SUNDRY NOTICES AND REPORTS ON WELLS

8 Well Name and No
North Indian Basin Unit #23

RE: Plugging and Abandonment Requirements, Conditions of Approval

North Indian Basin Unit No. 23

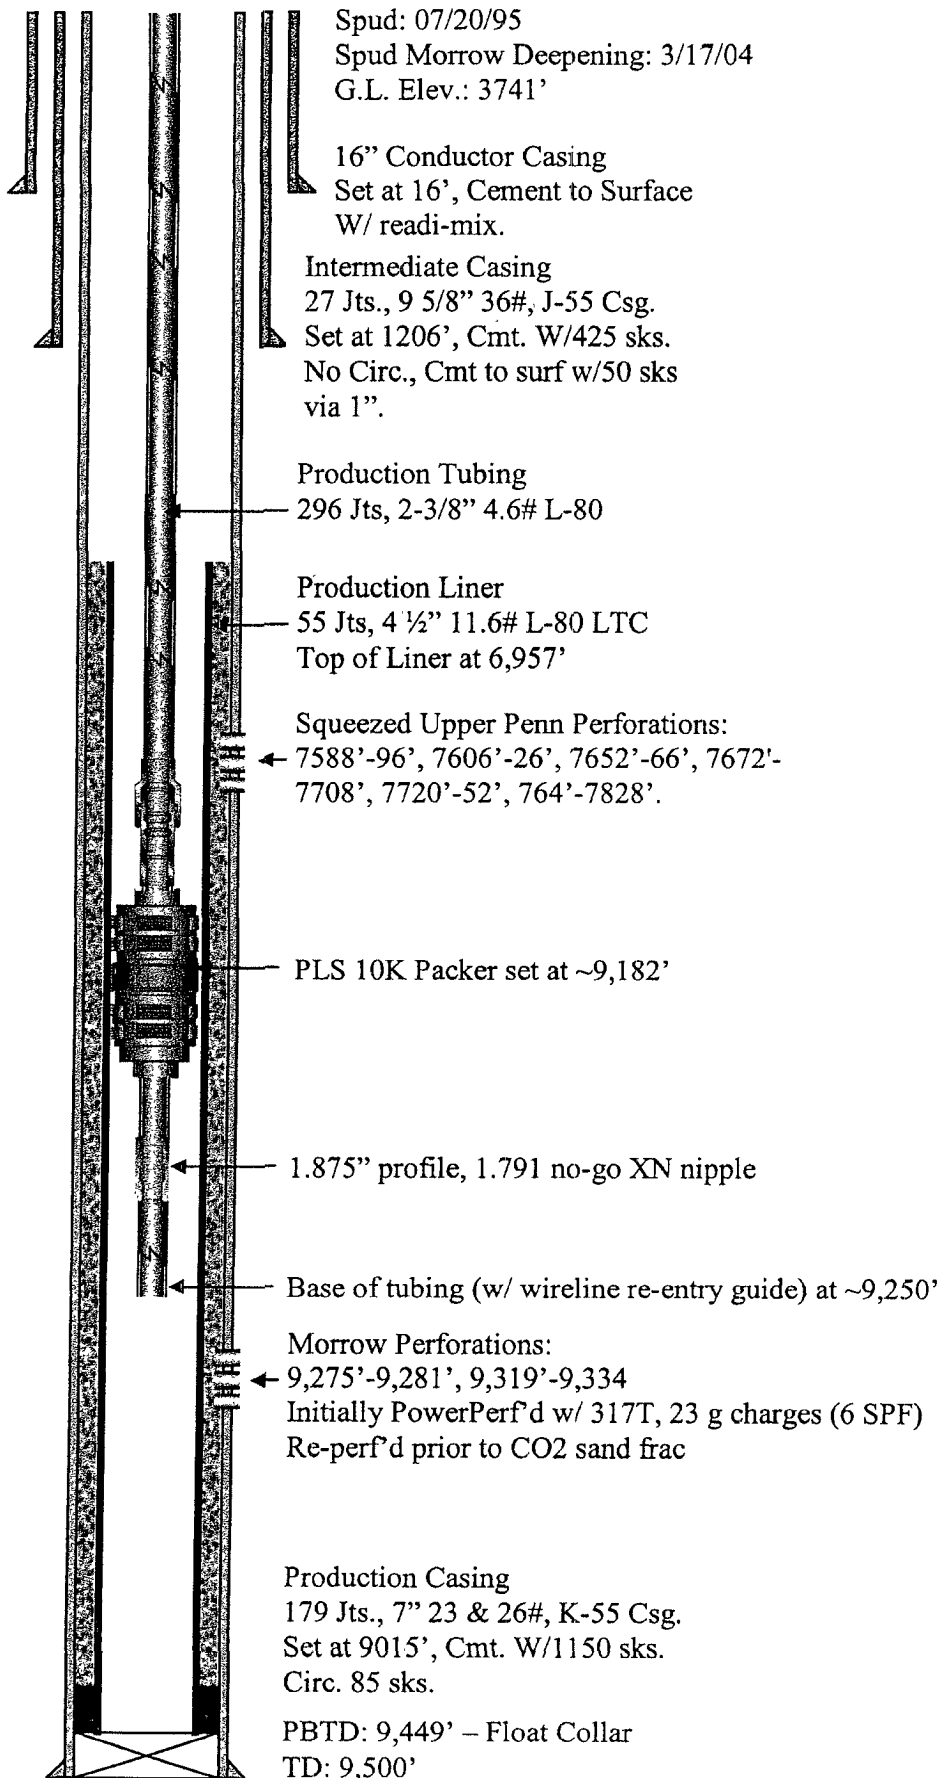
1. OK as is.
2. OK as is.
3. Spot a balanced plug from 7042'-6872' (covers the top of liner). WOC and tag.
4. Spot a balanced plug from 6390'-6230' (covers the DV tool).
5. Spot a balanced plug from 5624'-5774' (covers the Wolfcamp top).
6. Spot a balanced plug from 4154'-4014' (covers Bone Spring top).
7. Spot a balanced plug from 2131'-2251' (covers the Glorieta top).
8. Spot a balanced plug from 1258'-1156' (covers 9-5/8" shoe). WOC and tag.
9. Perforate 7" casing at 250', attempt to squeeze adequate cement to circulate cement to surface in/out of the 7" casing. If not able to squeeze spot cement and bring to surface inside the 7" casing
